MFN 06-407
Supplement 13

Subject: Revised Response to Portion of NRC RAI Letter No. 166 Related to ESBWR Design Certification Application - DCD Tier 2 Section 3.8 – Seismic Category I Structures; RAI Number 3.8-94, Supplement 3

Revised Response to Portion of NRC RAI Letter No. 166

RAI Number 3.8-94 S03 (Revision 1)

Figure 3.8-94(37) FRS (Compared with the DAC3N) – FWS Basemat Z

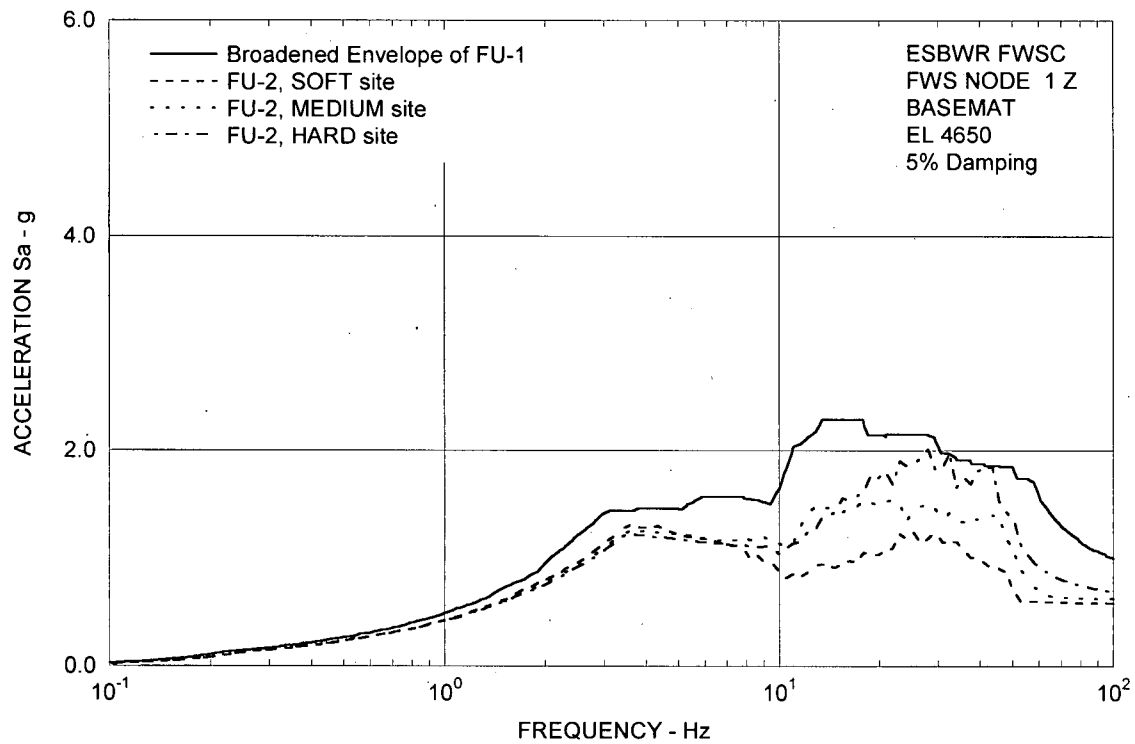
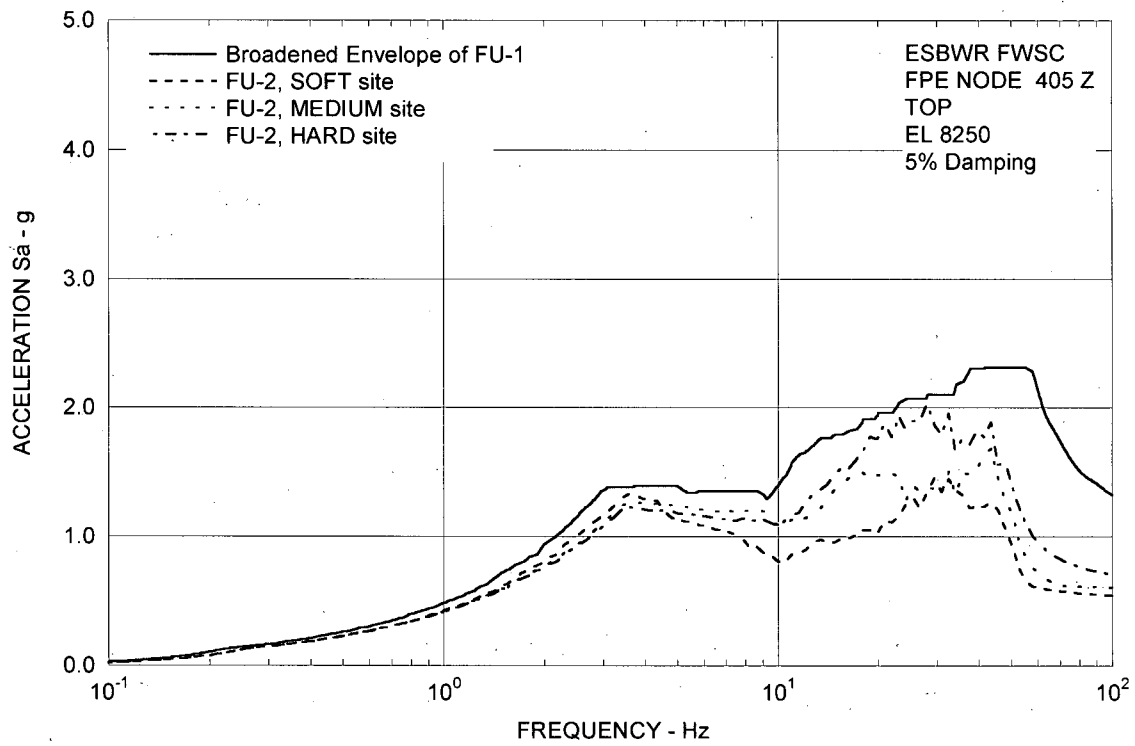
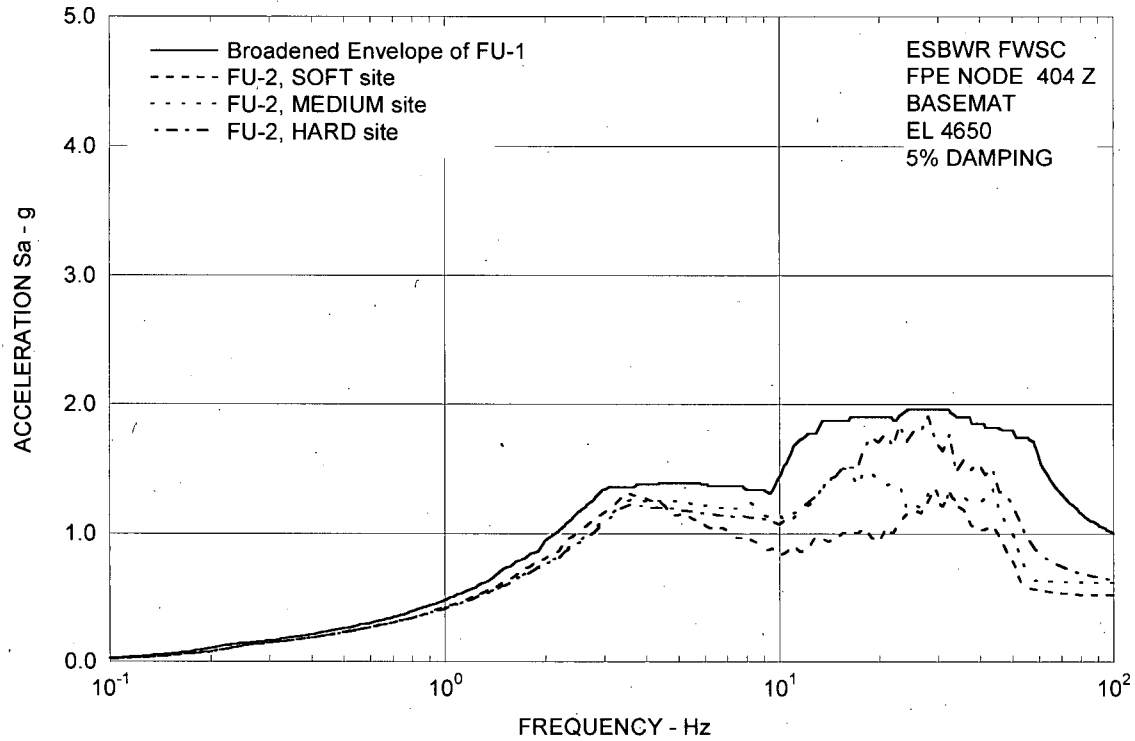
Comparisons of the response spectra are shown in Figures 3.8-94(4) through 3.8-94(15), Figures 3.8-94(16) through 3.8-94(27), and Figures 3.8-94(28) through 3.8-94(39), respectively for the X direction, Y direction, and Z direction. These comparisons will be added in DCD Revision 6 as DCD Tier 2 Figures 3A.8.7-1a through 3A.8.7-3l.

As for the RB/FB, it is found from the results that the responses for the SASSI2000 uniform cases are bounded by the broadened envelope responses of the DAC3N cases in the whole frequency range. The responses of the RU-8 uniform hard site at the vent wall top (X direction per Figure 3.8-94(6)) and the refueling floor (Z direction per (Figure 3.8-94(28)) at around 20 Hz are slightly higher around 20 Hz but the exceedance is negligibly small.

On the other hand, the response spectra of a portion of the CB above ground and the FPE in the FWSC exceeded greater than 10% at the broadened envelope responses of the DAC3N cases in the higher frequency range.

Thus, the SASSI2000 uniform site results of the CB and the FWSC are included where appropriate to obtain the enveloping design spectra. DCD Tier 2 Figures 3A.9-1g, 3A.9-1l, 3A.9-2g and 3A.9-3g will be revised in Revision 6 accordingly.
